Access Compliance Report

Public Rights-of-Way

(Curb Ramps)

Intersection ID: 14095	Main Street: CAMDEN_RD	Cross Street: W_WORTHINGTON_AV	Location: NE
ADA ID: F7251F16779E	Ramp Type: Perp	Initial Pass/Fail: Fail	Overall Compliance: No
			Severity Score: 13.75

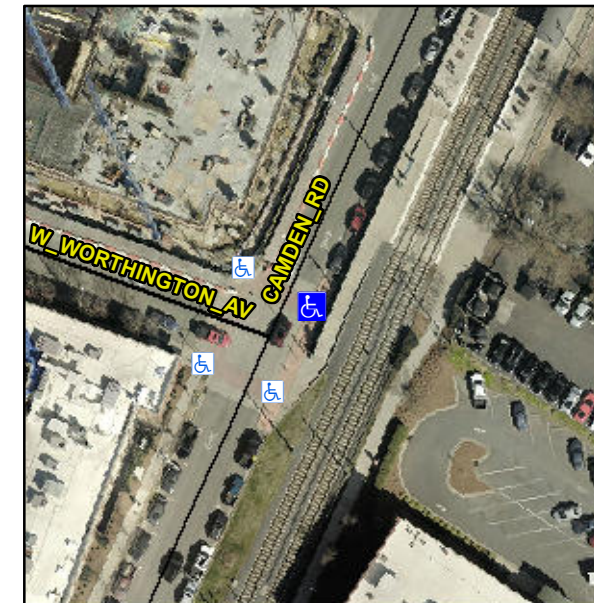
Not Found, R304.2.2, R304.5.3

Compliance	Description	Data	Compliance	Description	Data
N/A	Ramp Length (in)	96.0	No	Ramp Slope (%)	10.2
Yes	Ramp Width (in)	128.0	No	Ramp XSlope (%)	2.6
N/A	Flare Type LT	N/A	N/A	Flare Type RT	N/A
N/A	Flare Slope LT (%)	N/A	N/A	Flare Slope RT (%)	N/A
N/A	Flare Traversable LT?	N/A	N/A	Flare Traversable RT?	N/A
N/A	Landing Length (in)	N/A	N/A	DWS Provided?	N/A
N/A	Landing Width (in)	N/A	N/A	DWS Contrast?	N/A
N/A	Landing Slope (%)	N/A	N/A	DWS Length (in)	N/A
N/A	Landing X Slope (%)	N/A	N/A	DWS Full Width?	N/A
N/A	Landing Curb? (Y/N)	N/A	N/A	DWS Offset (in)	N/A
N/A	Shared Landing?	N/A			
N/A	Gutter Ponding?	N/A	N/A	Gutter Slope (%)	N/A
N/A	Gutter Lip Ht (in)	N/A	N/A	Gutter X Slope (%)	N/A
N/A	Painted X Walk1?	Yes	N/A	Painted X Walk2?	N/A
	X Walk 1 Direction	To NW		X Walk 2 Direction	N/A
N/A	X Walk 1 Width (in)	130.0	N/A	X Walk 2 Width (in)	N/A
	X Walk 1 Slope (%)	2.0		X Walk 2 Slope (%)	N/A
	X Walk 1 X Slope (%)	0.4		X Walk 2 X Slope (%)	N/A

Remove & Replace Entire Ramp.
